Re: **Kerr-McGee Chemical Corporation LLC (KM)**  
**NDEP Facility ID #H-000539**  
Nevada Division of Environmental Protection Response to:  
*Supplemental Phase II Report – Environmental Conditions Assessment*

Re: **Kerr-McGee Chemical Corporation LLC (KM)**  
**NDEP Facility ID #H-000539**  
Nevada Division of Environmental Protection Response to:  
*Background Investigation Work Plan* dated March 29, 2005

Subject: NDEP Facility ID H-000539 – Kerr-McGee ECA – *Background Study Work Plan – Groundwater and Soils* - Kerr-McGee Response to NDEP May 6, 2005 Comments

**Attachment A**  
**Kerr-McGee response to NDEP**  
**Comments on the Background Investigation Work Plan**  
**dated March 29, 2005 – Letter Dated May 6, 2005**  
**Henderson, Nevada**

Modified from Levinson, 1980

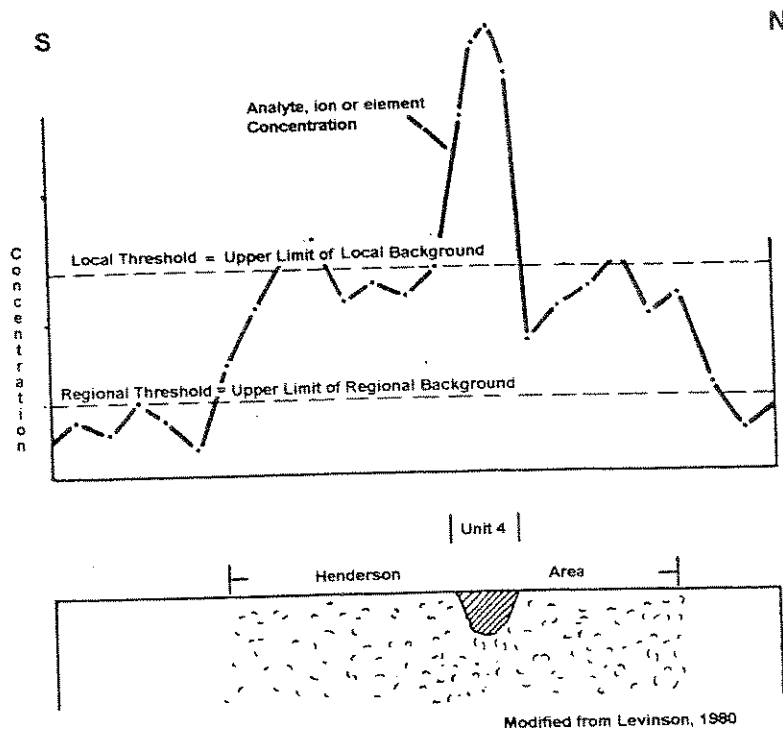
2. General comment, this report does not discuss the statistical methods that will be used to evaluate the background data once it is collected. It is suggested that KM describe the statistical methods that will be used to evaluate the background data in the revised version of this report.

From this figure it can be seen that the regional upper limit of background (the regional threshold) can be considered a "plain" whereas the local upper limit of background (the local threshold) can be considered a "plateau" and the anomalies are represented as peaks. The definition of local backgrounds and thresholds, and the distinction between local and regional backgrounds and thresholds, are of great importance in the interpretation of chemical data.

By way of example, the bottom of the figure shows a theoretical cross section from the Black Mtns. on the south, through the Henderson and the BMI Complex areas, to Frenchman's Mtn on the north. This clearly illustrates the relationship of the higher local Henderson area background to the lower background of the surrounding region and the higher anomalous background in the Unit 4 area to the lower relative background of the Henderson area.
